NEW MILLENNIUM PROJECT CONFIGURATION CHANGE REQUEST

PROGRAM <u>EO-1</u>		TITLE CHANGES TO EO-1 S/C TO WARP ICD-26	
CCR NO. <u>0018</u>		ORIGINATOR <u>T. Smith/GSFC</u>	
MTE INITIATED <u>09/1</u> <u>6/98</u>		ORIGINATOR'S CHG. NO. _____	
		SPONSOR/CODE <u>T. Smith/EO-1 WARP</u> PHONE <u>x0651</u>	
EFFECTIVITY		CHANGE CLASS

GODDARD SPACE FLIGHT CENTER		1. PAGE 1 OF 3
PRELIMINARY SPECIFICATION CHANGE NOTICE (PSCN) No. _____		2. INIT. DATE: 9/16/98
or PRELIMINARY INTERFACE REVISION NOTICE (PIRN) No. 001 <i>R</i> I		3. CONTRACT NUMBER
4. ASSOCIATED CONTROL NUMBERS: EO-1CCR 0018	5. CI'S AFFECTED: EO-1 SC TO WARP ICD-26	6. DOCUMENT NUMBER: REVISION:
7. DESCRIPTION OF CHANGE:

Figure 3-1. WARP Block Diagram

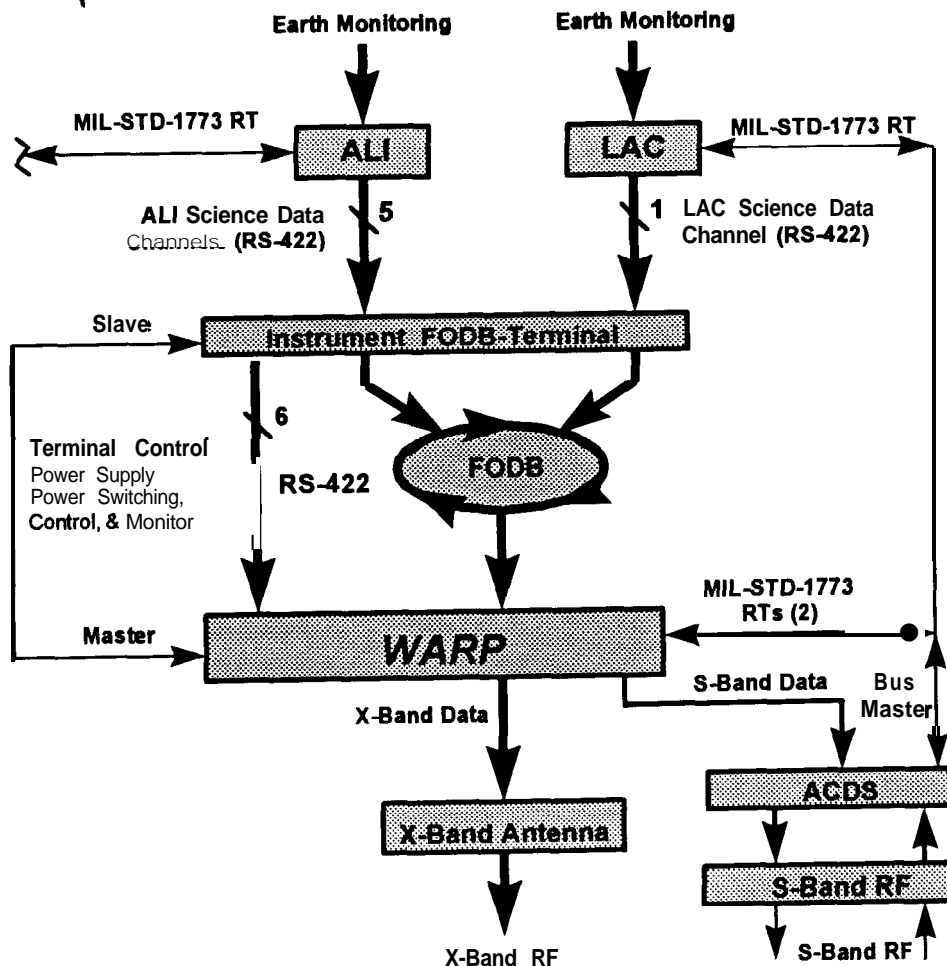
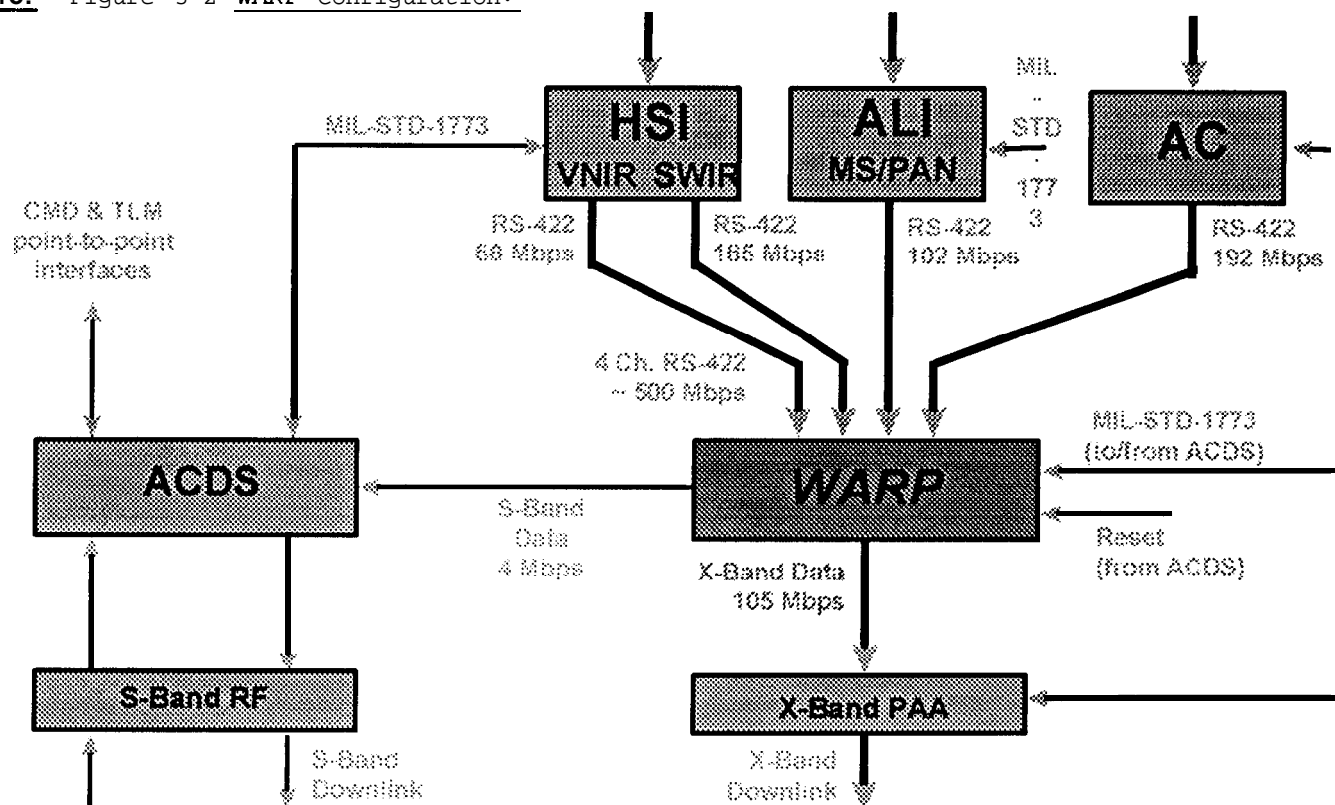
2. Change Figure 3-1 Warp Configuration

From:

ro: Figure 3-2 WARP Configuration:
